CONSTRUCTION BULLETIN 13-03

Masonry Sound Wall Structural Detail Updated

To alert construction personnel of an updated detail for masonry sound barrier wall construction.

DESIGN APPROVED <i>Shafiq U. Hasan</i>	ARIZONA DEPARTMENT OF TRANSPORTATION INTERMODAL TRANSPORTATION DIVISION BRIDGE GROUP STRUCTURE DETAIL
APPROVED FOR DISTRIBUTION <i>Teri A. Nehme</i>	SOUND BARRIER WALL (MASONRY)
ROUTE	PROJECT NO.
LOCATION	FA NO.
	DRAWING NO. SD 8.02 (2 of 2)
	SHEET NO. 0F

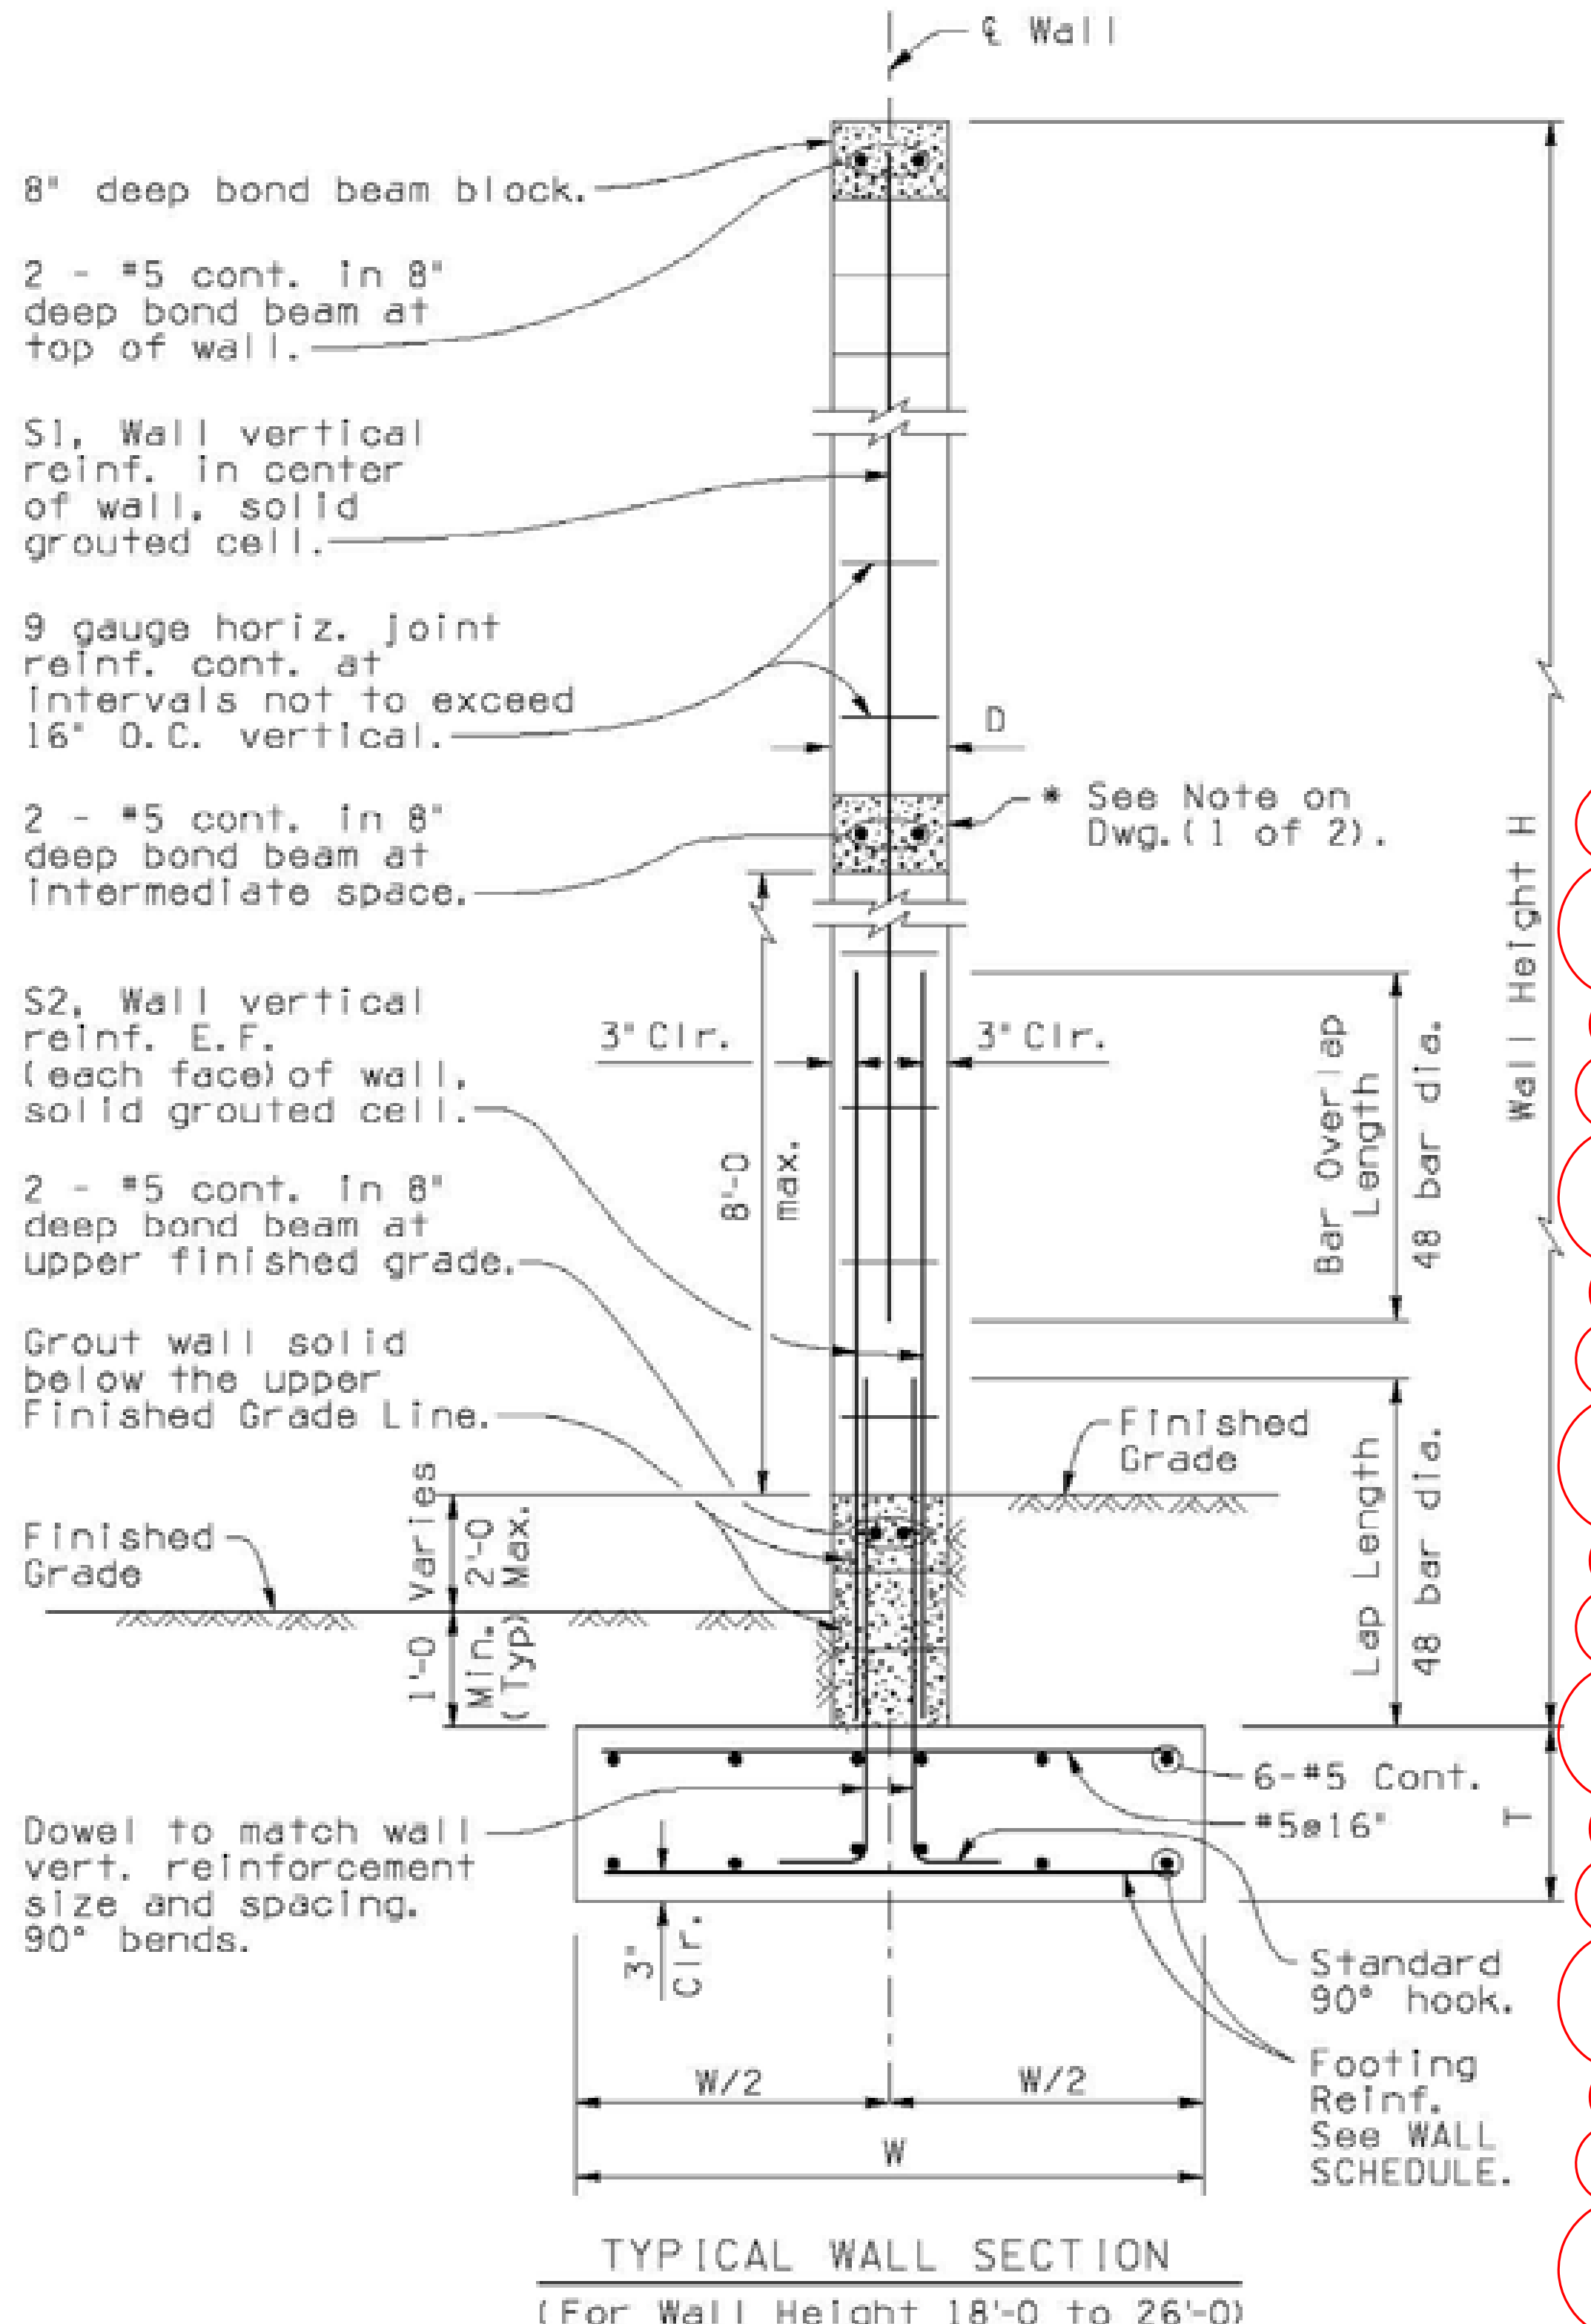
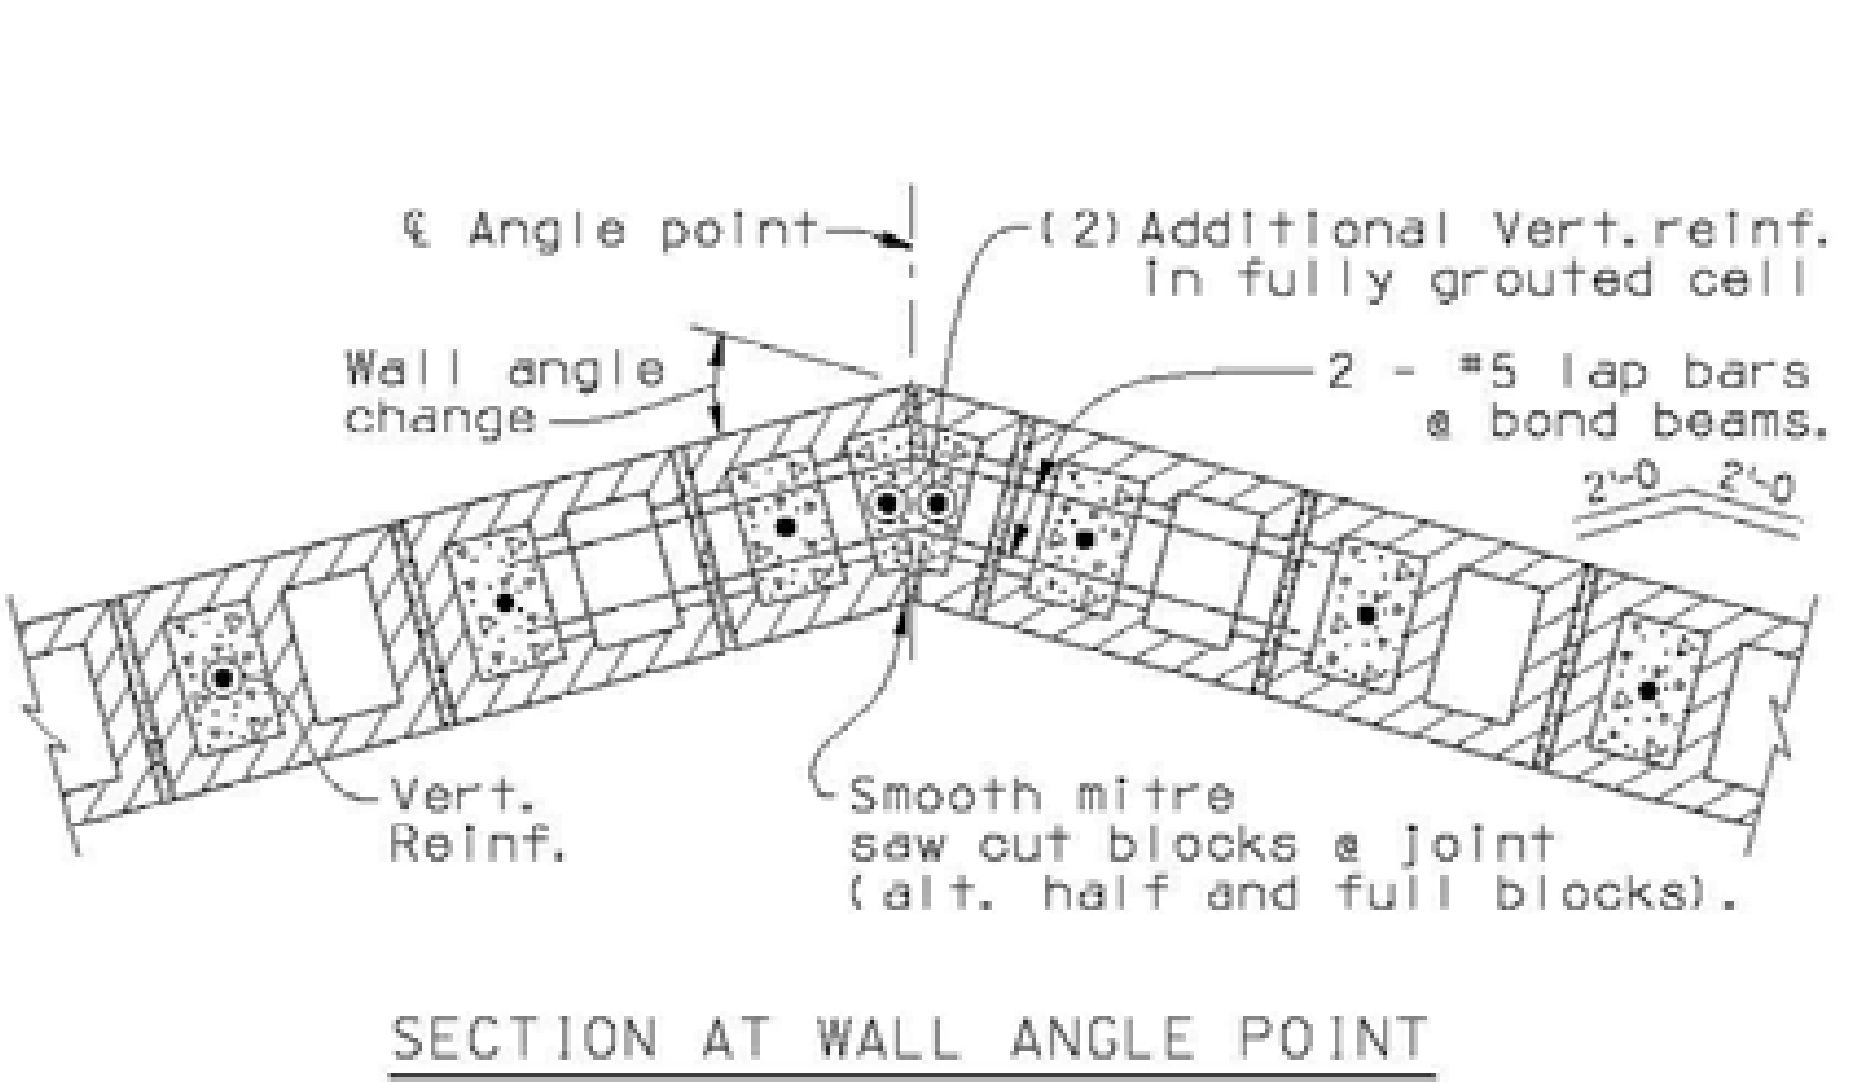
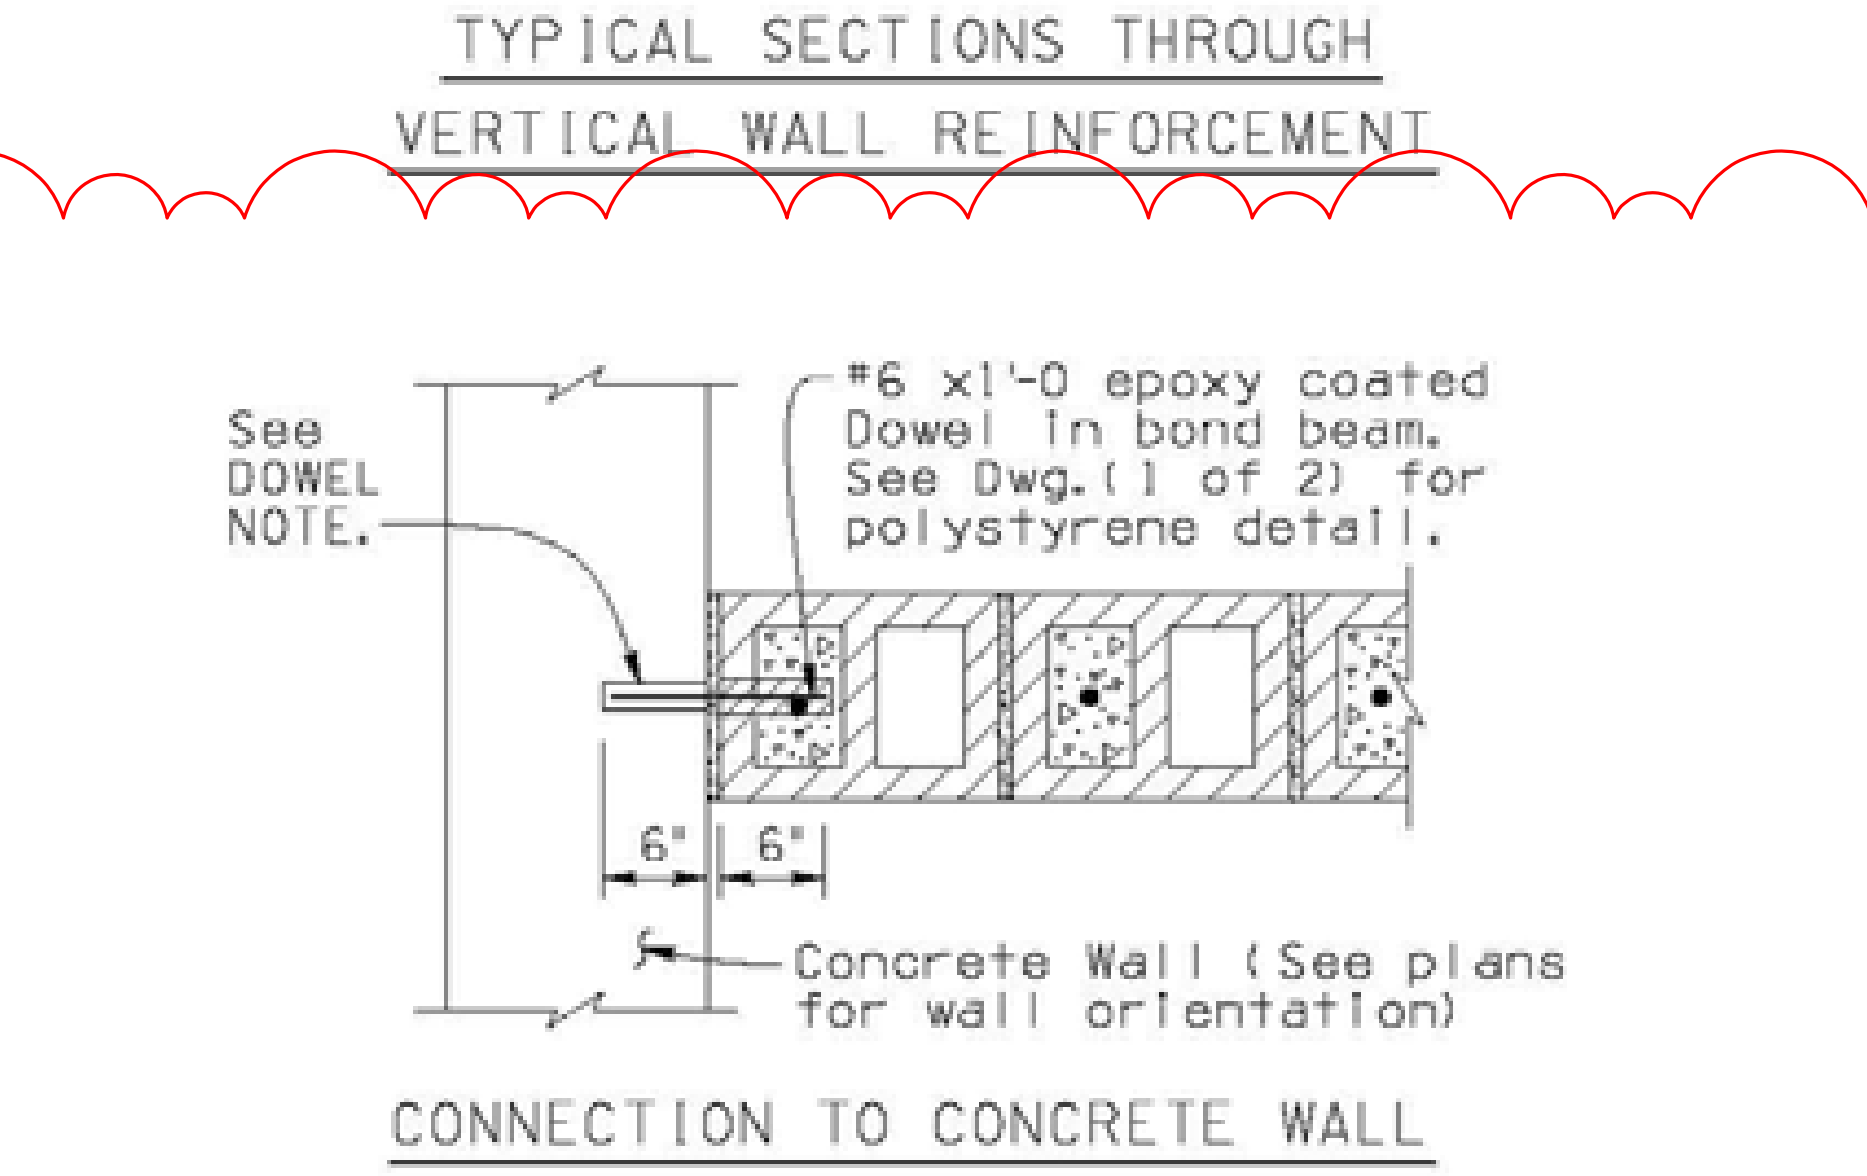
The Department has experienced inconsistency in the detailing and construction of masonry sound barrier walls at angle points. The lack of a continuous bond beam and running bond resulted in some minor separations at wall angle points. To ensure consistency with joint workmanship, a typical section at the wall angle point was incorporated into Structure Detail Drawing [SD 8.02-2](#). Designers were informed of the update January 23, 2013 through issuance of [Bridge Bulletin 2013-1](#).

NO	DESCRIPTION OF REVISIONS	DATE
1	Original Issue	4-03
2	Revised Reinforcing, General Update	02-07
3	General Update	1-10
4	Added Details for Conn. to Conc. Rd. and Ret. Wall Point	01-13

It is anticipated this change will apply to very few ongoing projects; a procedural change order should be executed for applicable projects. It is not required to correct wall angle points where construction has been completed, however such locations should be inspected for proper workmanship.
